**Plymouth South High School**  
Plymouth, MA  
Ai3 Project # - 1308.00

**Addendum #2**

June 11, 2015

DRAWN BY:	JCJ	SKT-001
SCALE:	NTS	
JOB NO:	1308.00	
DATE:	06/10/15	
REF DWG:	T2.8

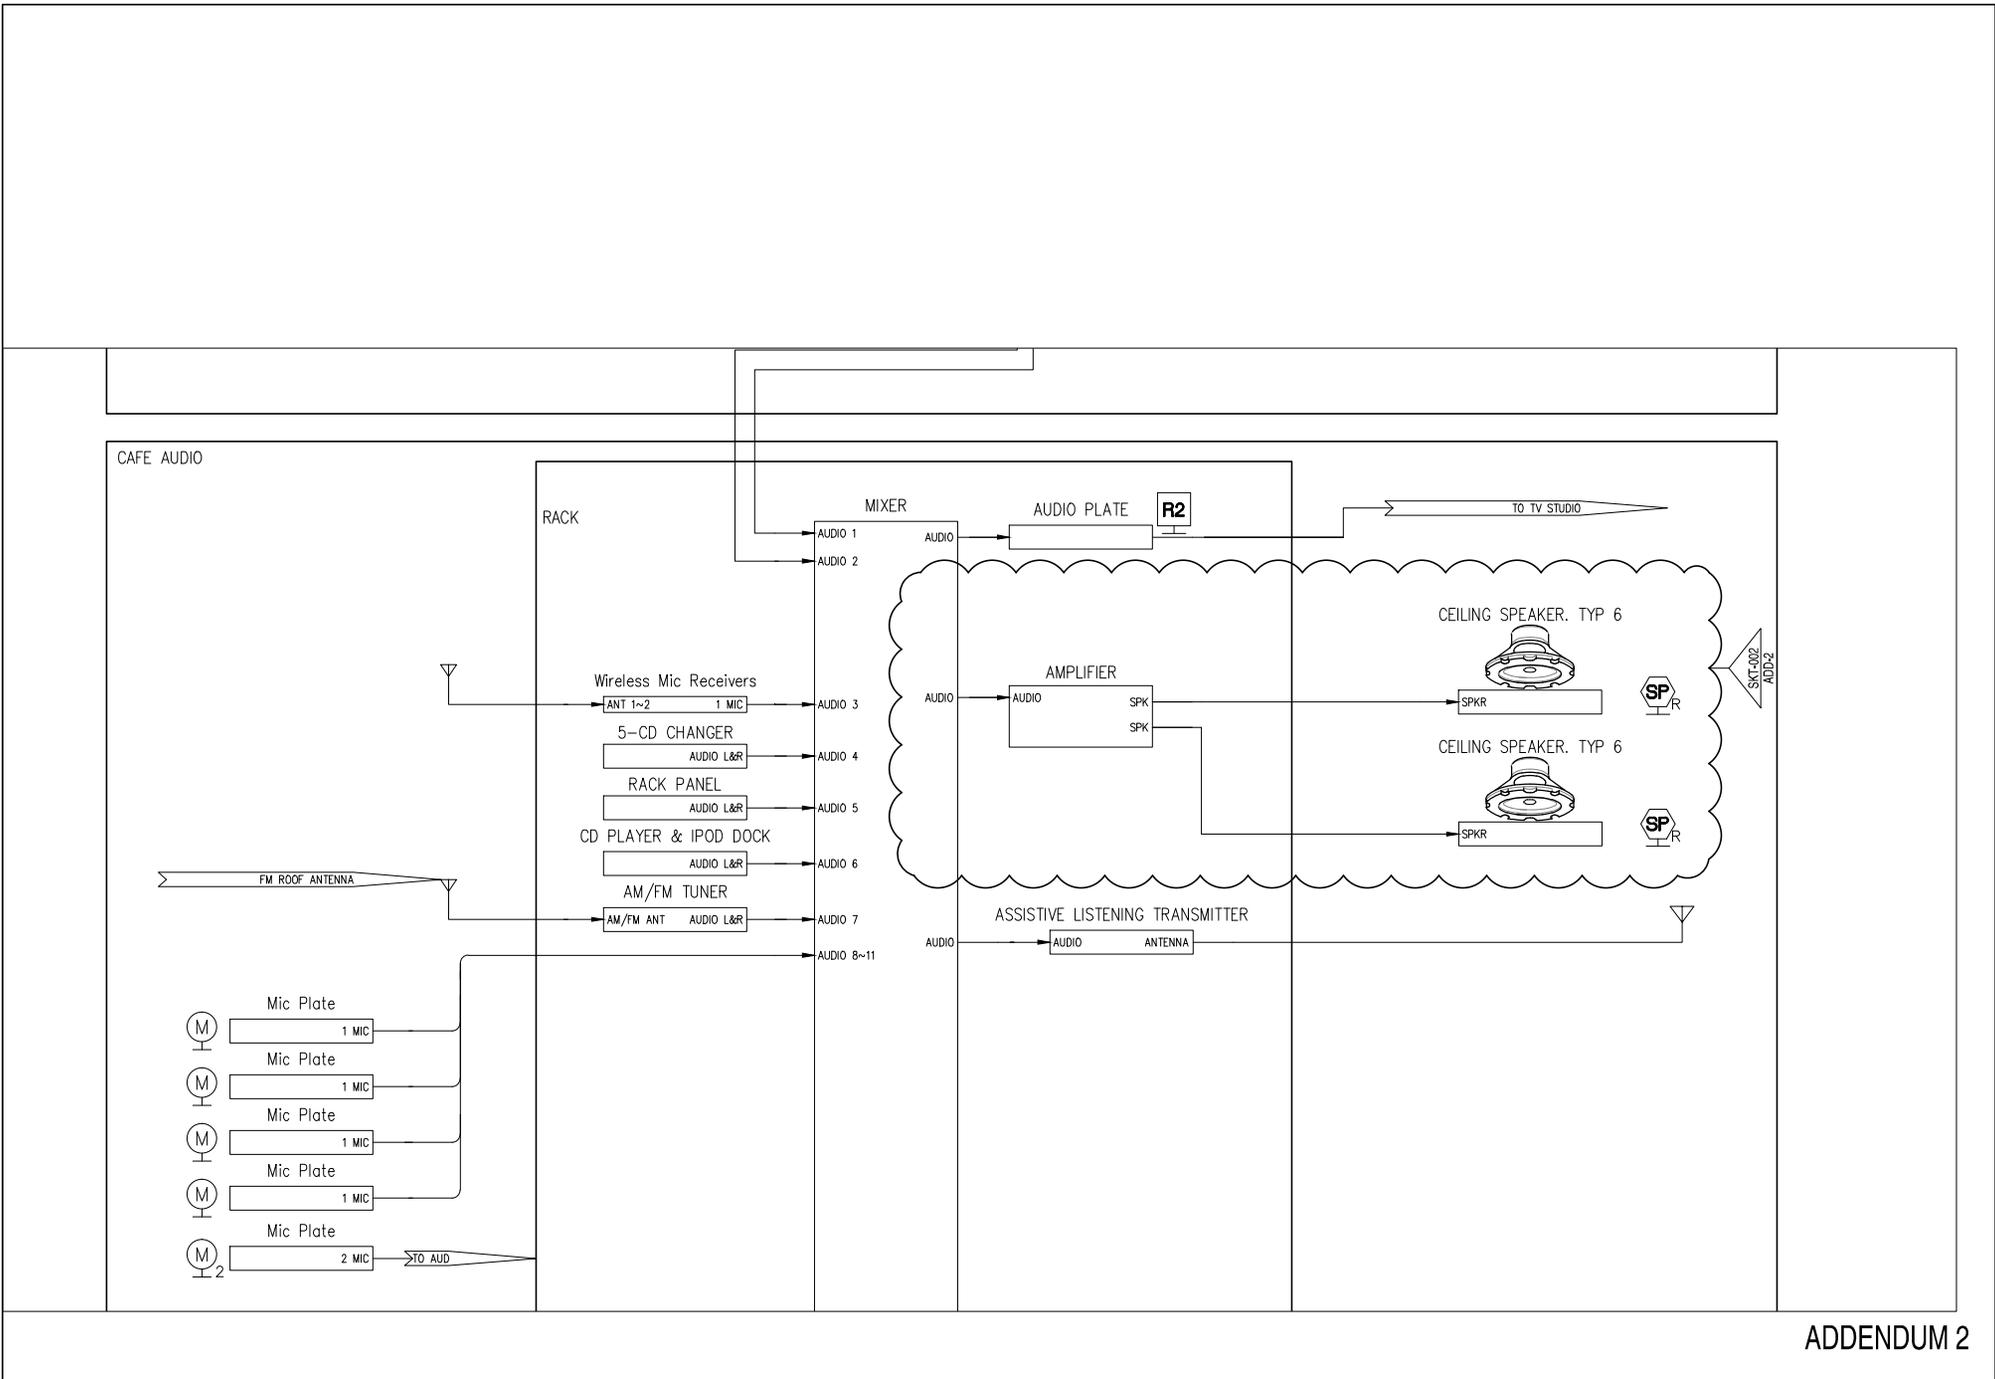
- ADD 2-0109 CLARIFICATION: In the Seminar room, the wireless microphone systems shall be installed in the cabinet on the first floor, as specified, not in the system rack as shown on T2.8 detail 1. Remote antennas, brackets, and antenna distribution equipment is required to place the antennas in the room for complete coverage.

- ADD 2-0110 CLARIFICATION: In Seminar room, a second rack is to be provided and installed inside the cabinet on the first floor for equipment mounting. DR-12 by Middel Atlantic or equal. Secure rack to floor of cabinet. See 2.3.C.14.e. The equipment to be installed in this rack is the CD/iPod dock player and the 5 wireless microphones. These units are incorrectly shown on the T2.8 riser in the main rack.

- ADD 2-0111 CLARIFICATION: Subwoofer in Seminar room, detail number 1 on T2.8 shall be installed/wired in discrete mode as shown on the drawing.
- ADD 2-0112 Page 27 40 00-54 Section SMALL GROUP SEMINAR Article 2.3.C.8.s.2) at end of sentence add "Provide and install PoDM Power supply."

DRAWN BY:	JCJ	<b>SKT-002</b>
SCALE:	NTS	
JOB NO:	1308.00	
DATE:	06/10/15	
REF DWG:	T2.9

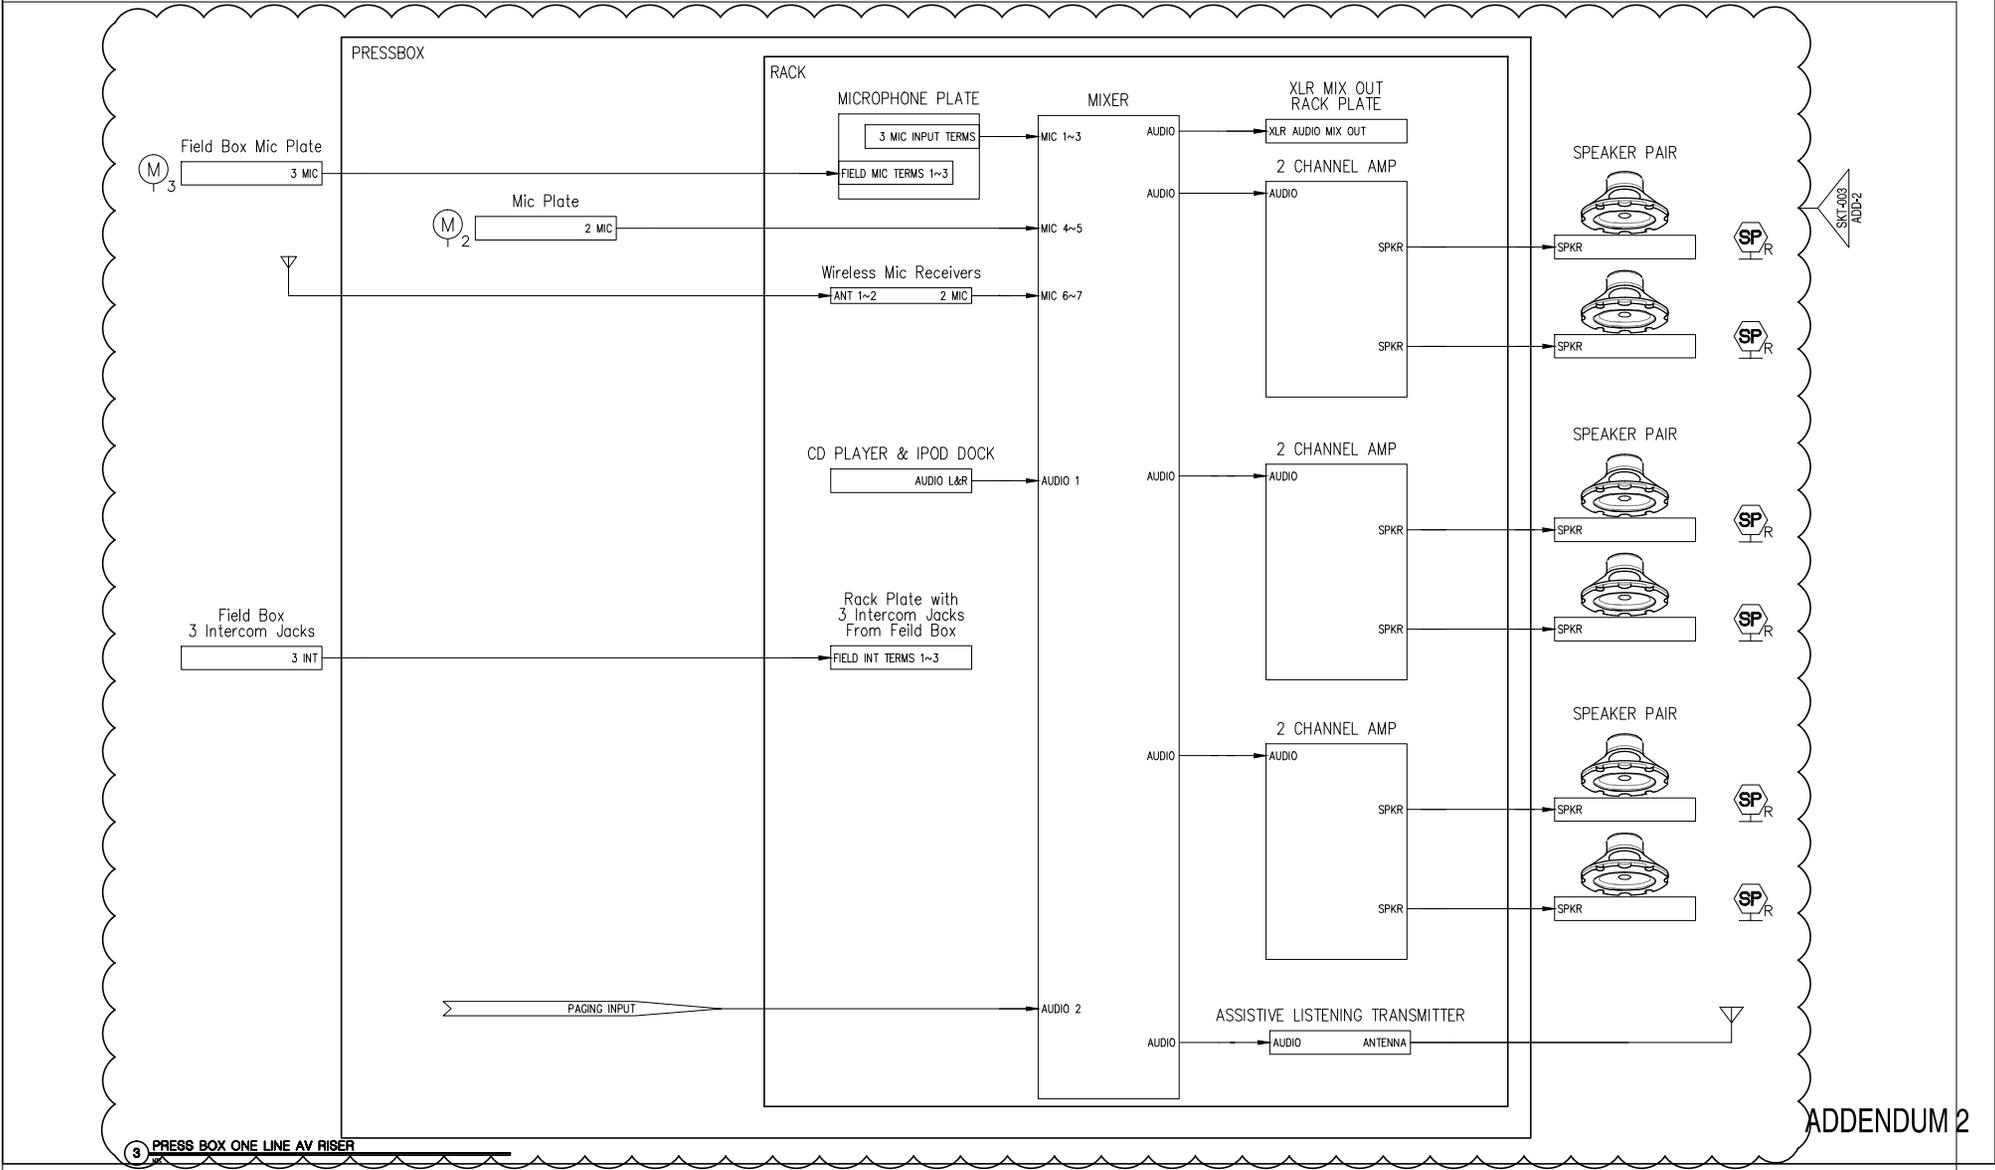
5) Receiver is Extron model DTP-HDMI-4K-330-RX or equal by Crestron or Kramer
- ADD 2-0123 CLARIFICATION: PE Center and Storage/Support Facility sound systems are nearly identical (minus the projector equipment) to the Student Dining sound system and as such the specified equipment in each section shall be installed in a similar fashion as stated and shown on T2.9 detail 1.

- ADD 2-0128 Page 27 40 00-86 Section PRESS BOX Article 2.10.A Revise 2.10.A to read:  
1. The PA system shall include a mixer and amplifiers. See detail 3 on T2.9.

**3 DOORWAY ACCESS CONTROL DETAILS**  
NTS

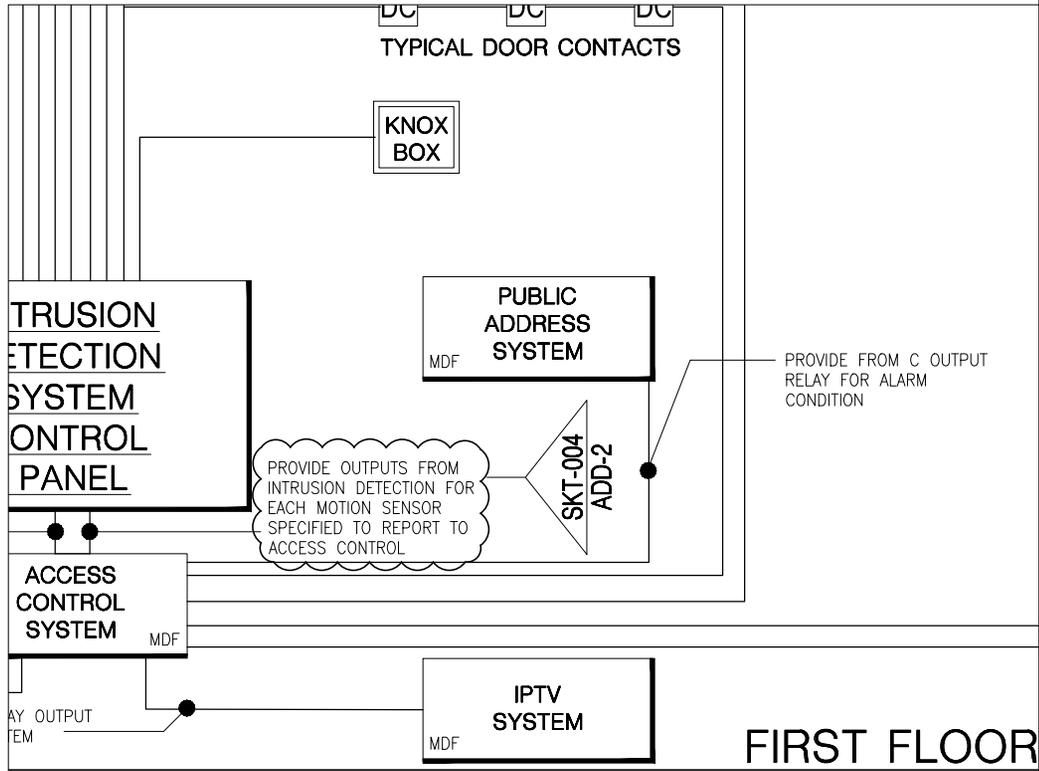
- ADD 2-0134 On drawing T2.11, detail 3, Revise the note for the 6"x6"x3" J-box to read: "Electrical subcontractor shall provide and install 6" x 6" x 3" Junction box at 18" above ceiling at every doorway with door contacts on the secure side of doorway. Electrical subcontractor shall provide and install a ¾" conduit from this junction box to the door position sensor."

ELECTRICAL SUBCONTRACTOR SHALL PROVIDE AND INSTALL 6" X 6" X 3" JUNCTION BOX 18" ABOVE CEILING AT EVERY DOORWAY WITH DOOR CONTACTS ON THE SECURE SIDE OF DOORWAY. ELECTRICAL SUBCONTRACTOR SHALL PROVIDE AND INSTALL A 3/4" CONDUIT FROM THIS JUNCTION BOX TO THE DOOR POSITION SENSOR.
